RE: Old Cutler Road Site Trip Generation Analysis-#14191

Responses to Town of Cutler Bay Development Review Comments (Review Date: 5/29/2019)

Re: Old Cutler Road Site Traffic Study, Second Submittal

EXHIBIT 4
Project Trip Distribution & Assignment

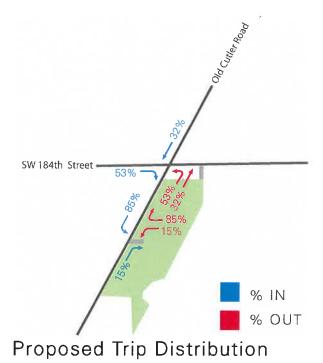
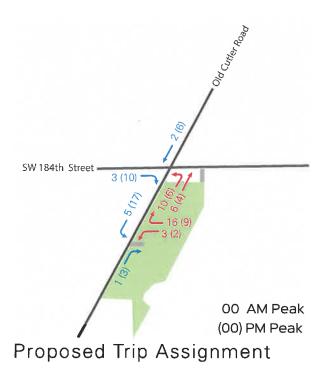
The elimination of the driveway accessing SW 184th Street would impact the Old Cutler Road/SW 184th Street intersections and the Old Cutler Road Driveway. The revised project trip distribution and assignment are graphically portrayed in Exhibit 4. Intersection capacity analysis was performed for these two intersections using Synchro for am and pm peak hour conditions. Worksheets are provided in Attachment C. The results are summarized in Exhibit 5.
